ADDENDUM NO. 2

March 1, 2022

**TIMOTHY BALL ELEMENTARY SCHOOL ADDITIONS, RENOVATIONS,
AND RELATED WORK
Crown Point, IN 46307**

This Addendum forms a part of and modifies the Bidding Requirements, Contract Forms, Contract Conditions, the Specifications, and the Drawings dated February 7, 2022 by Gibraltar Design. Acknowledge receipt of the Addendum in the space provided on the Bid Form. Failure to do so may subject the Bidder to disqualification.

© GIBRALTAR DESIGN SHEET
B A-703

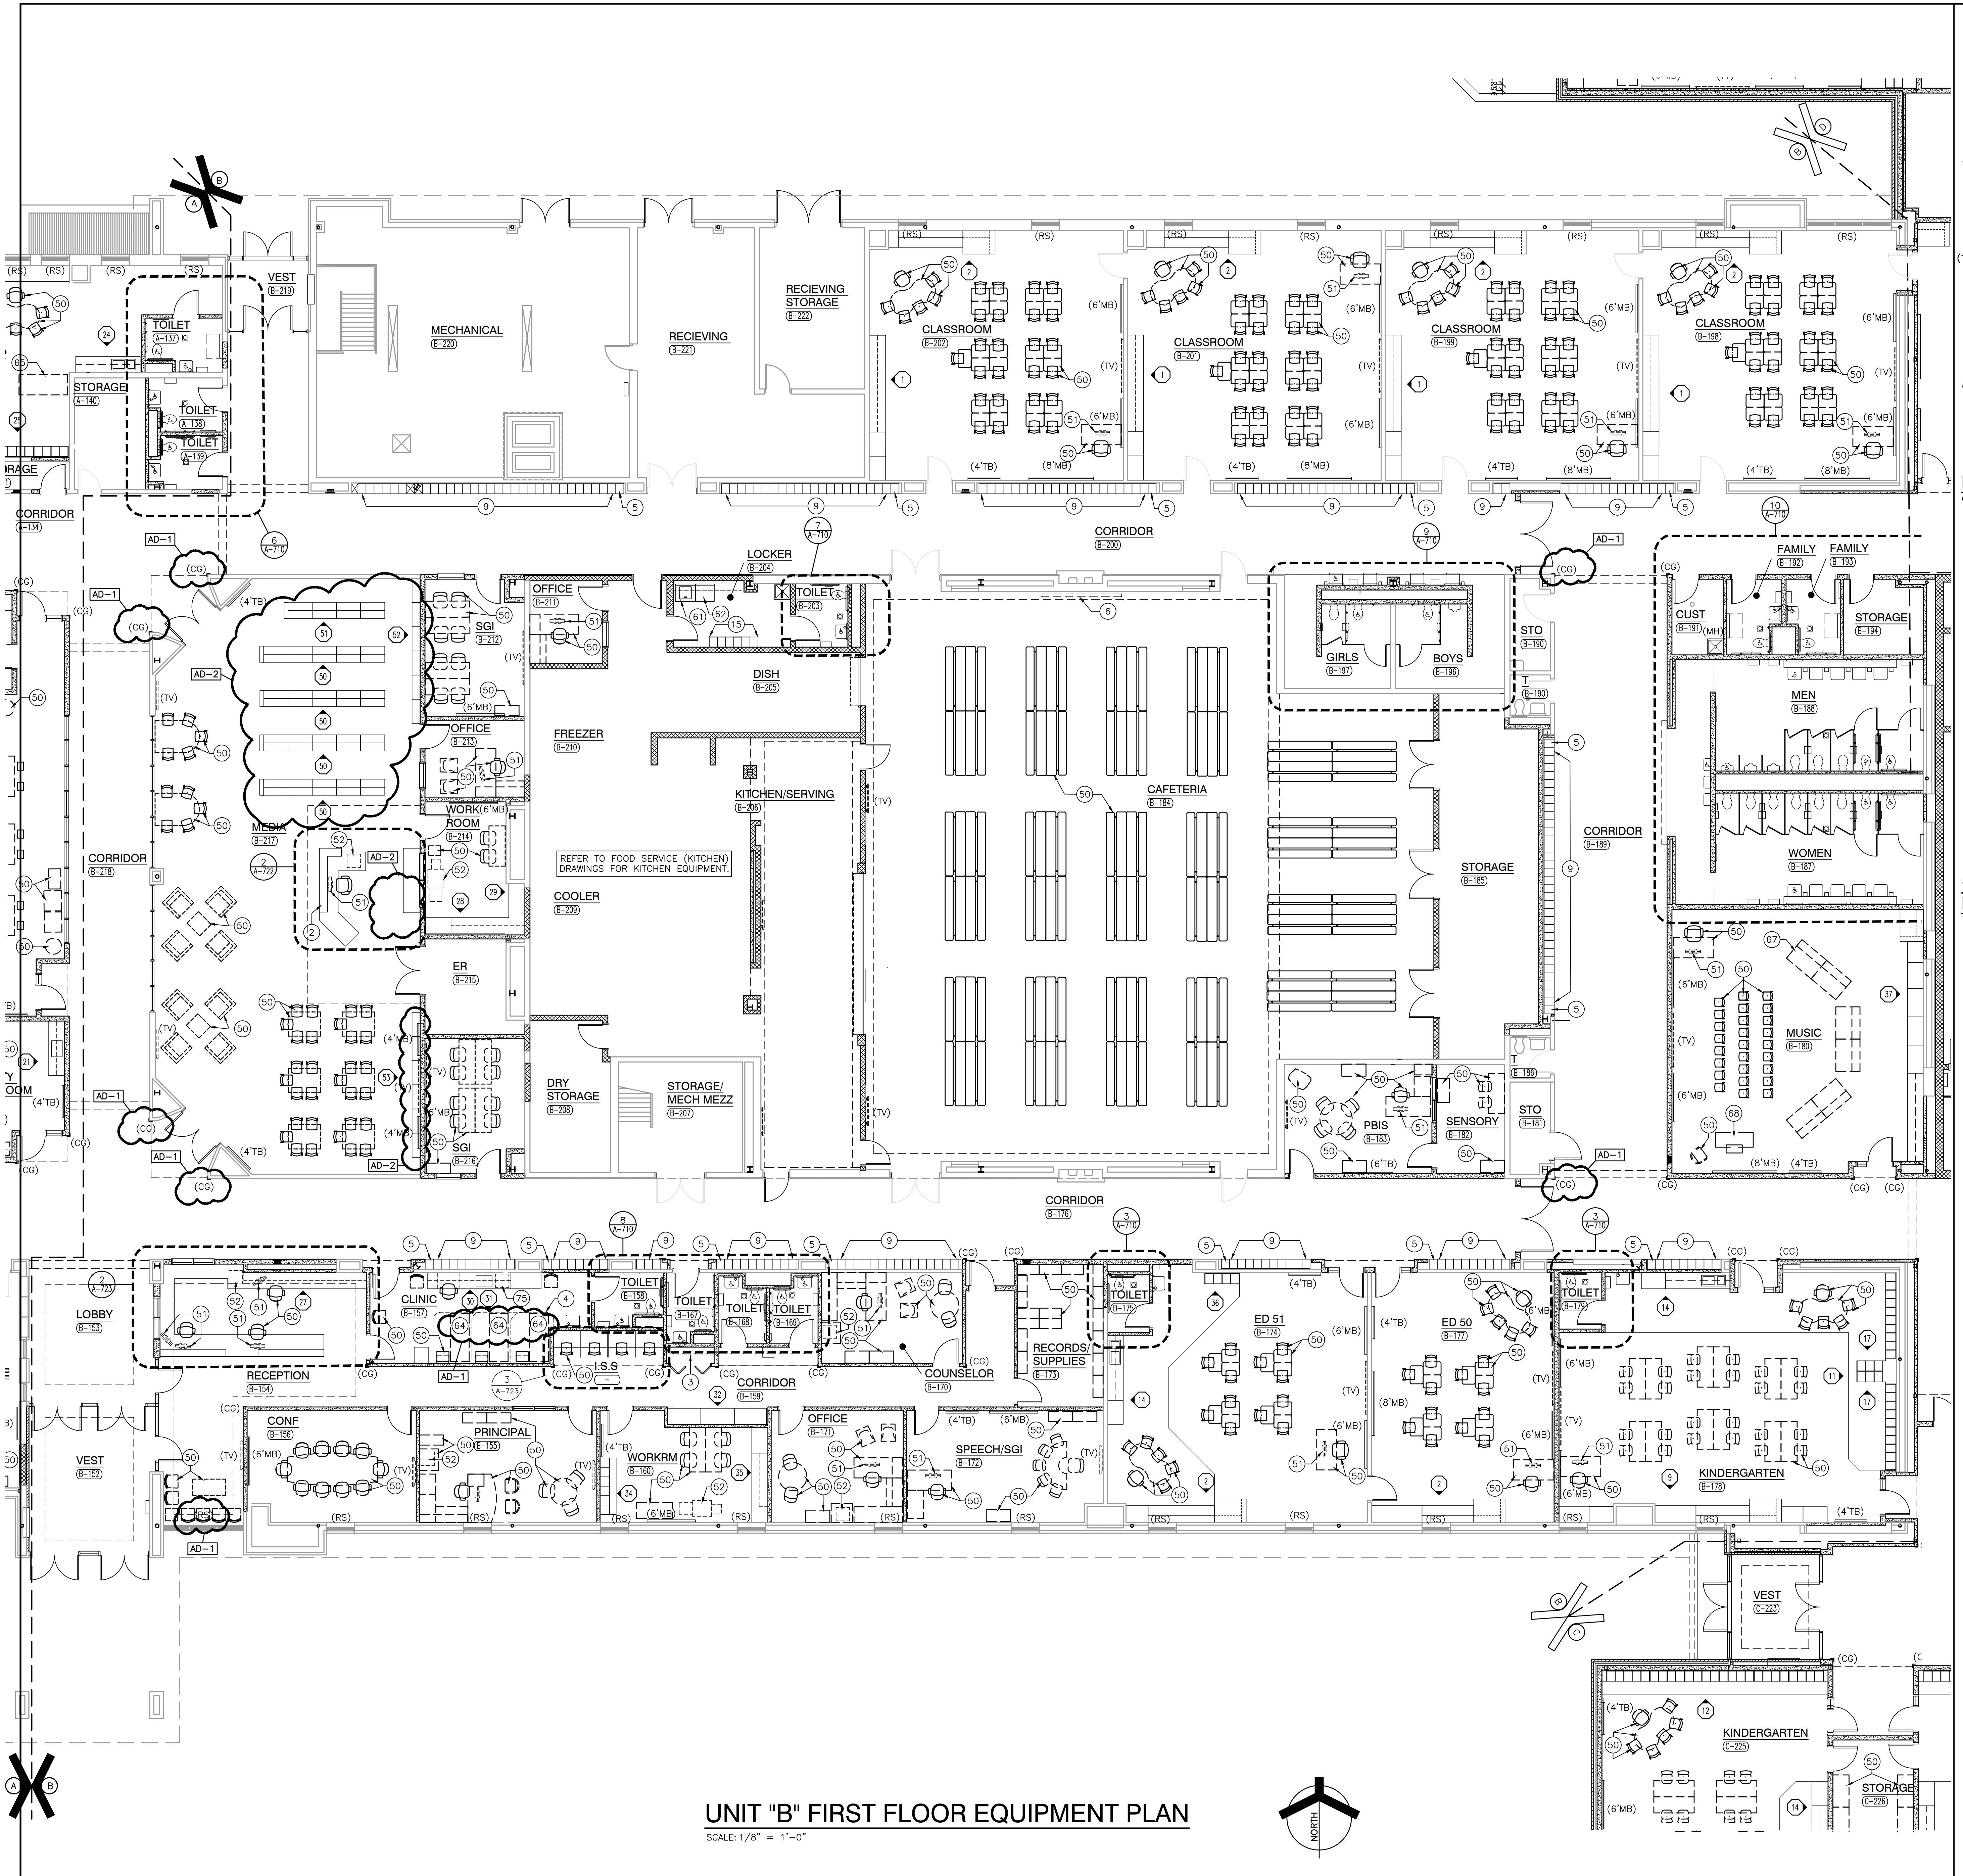
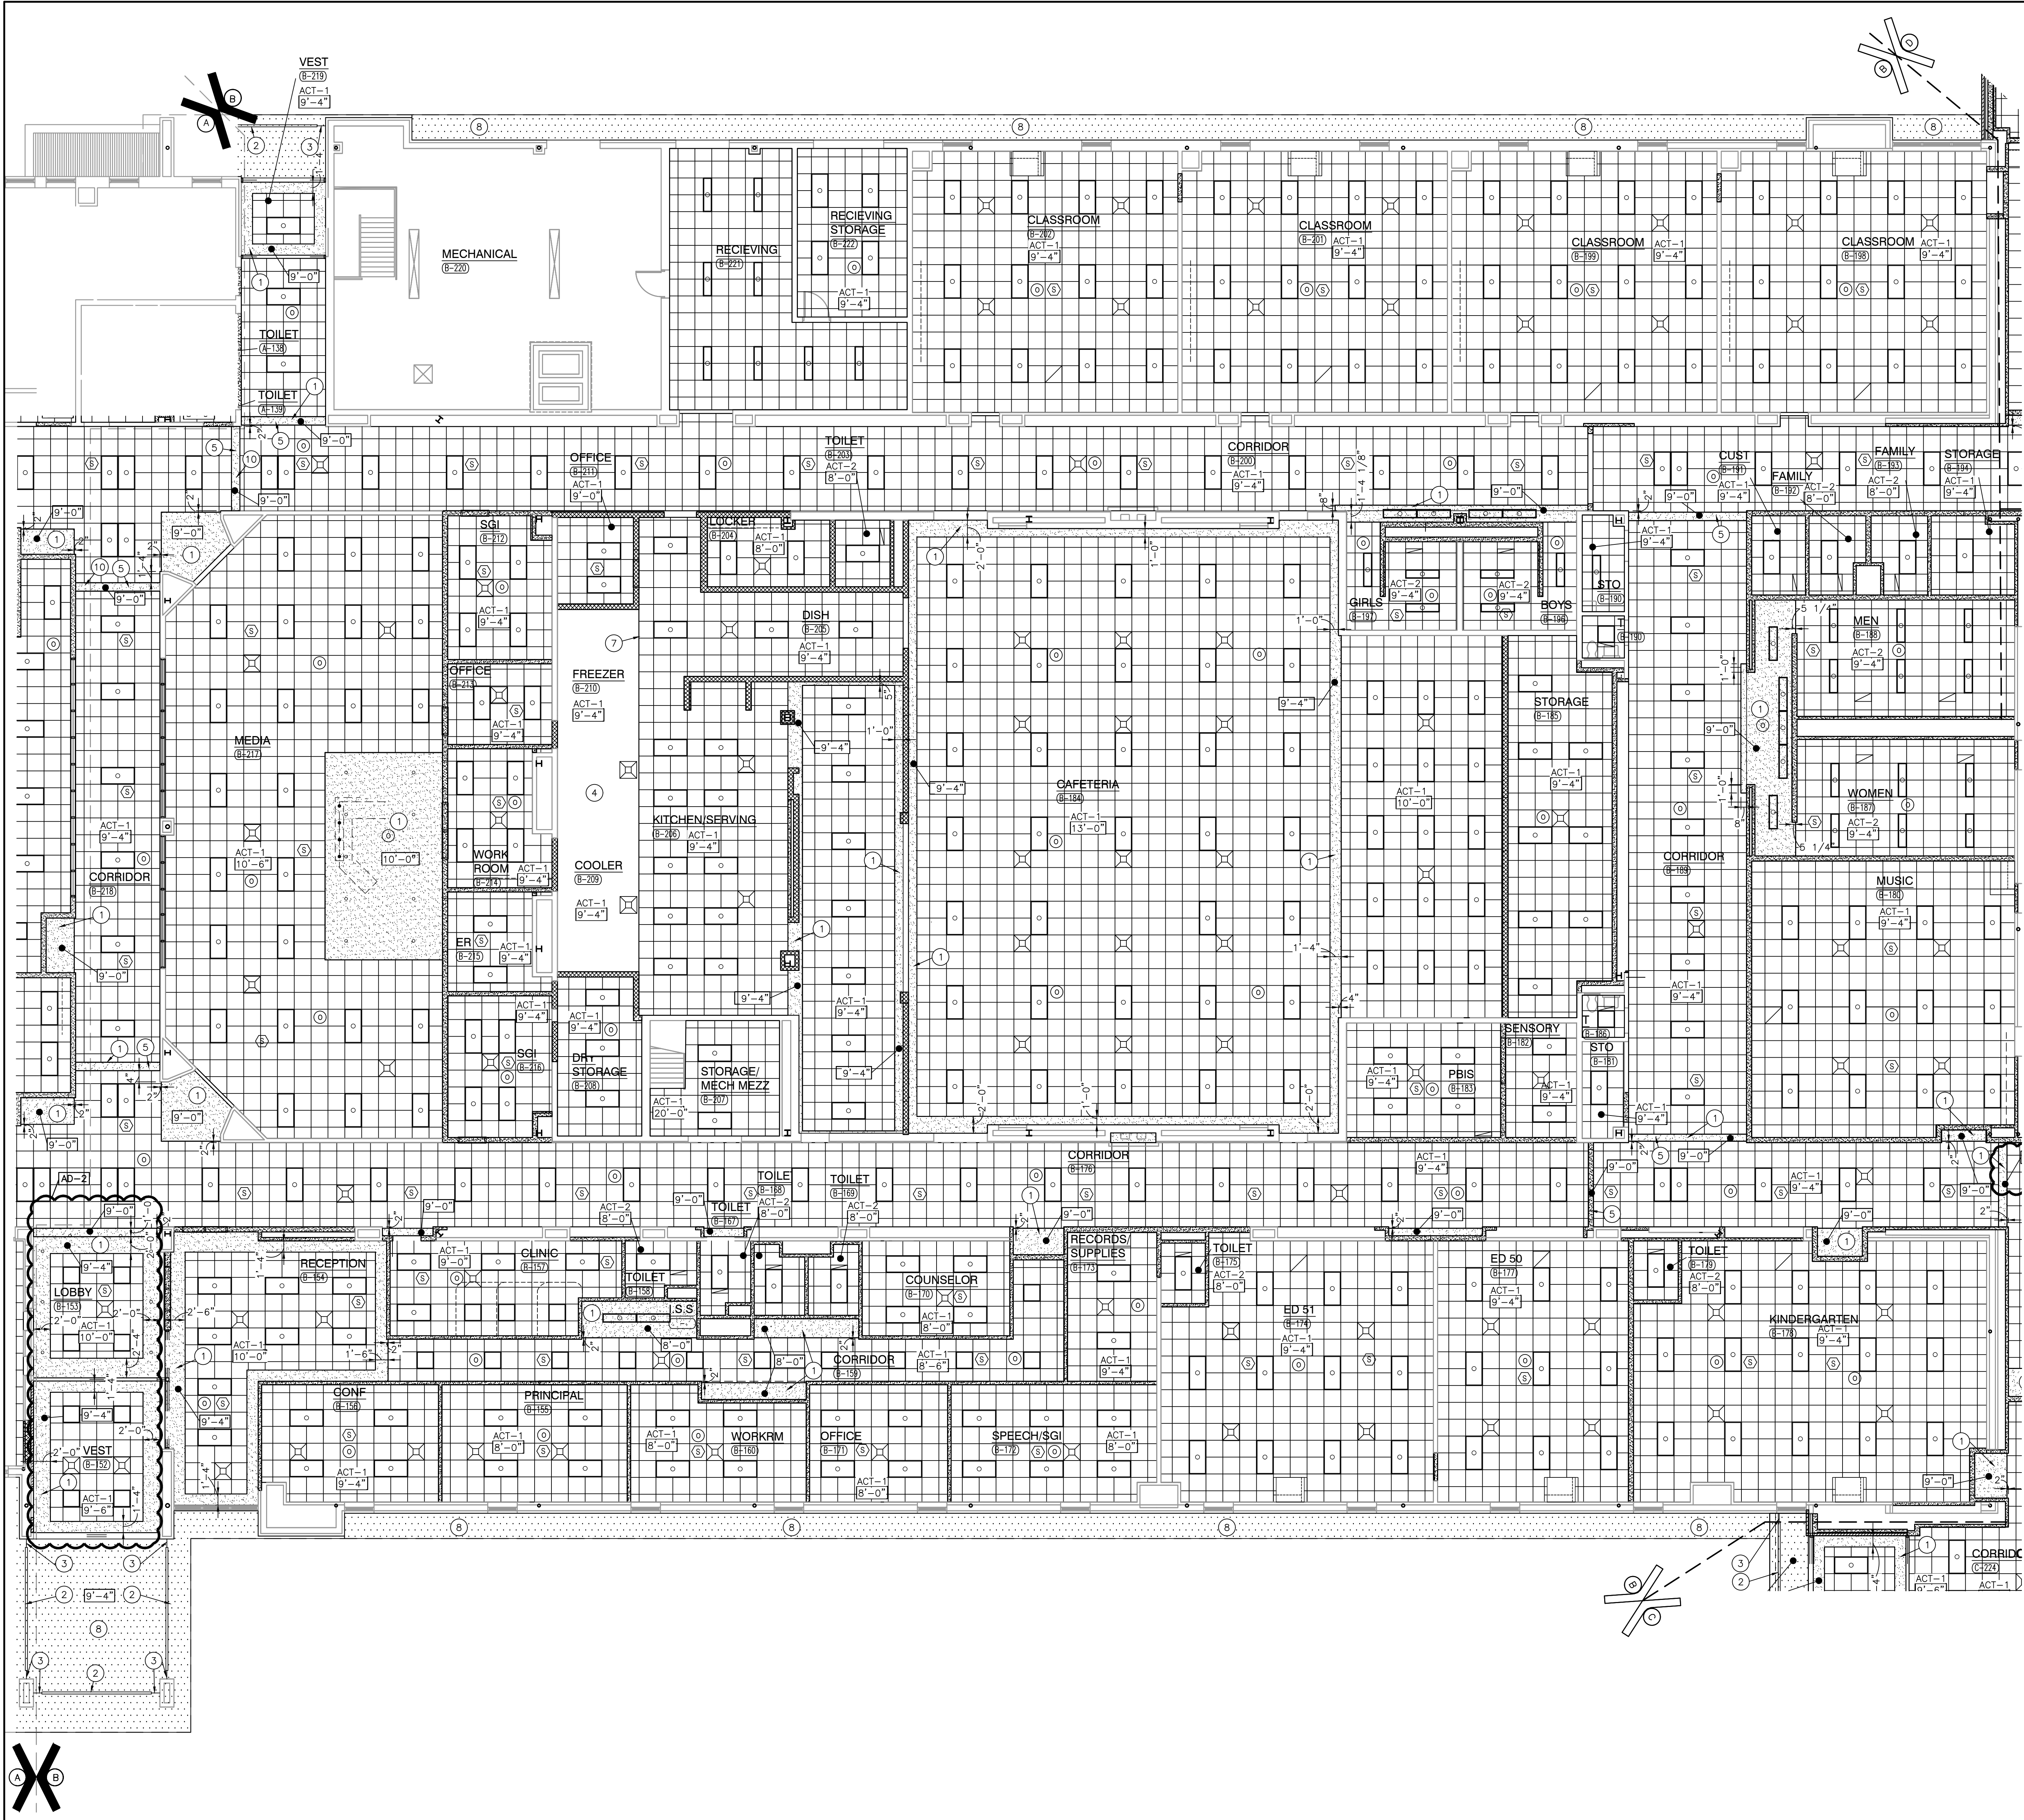
19. Sheet A-703

- A. Refer to revised, full size drawing, included in this Addendum, for the following revisions:
 - 1. Revise Media Center wood shelving to be shown as fixed casework.
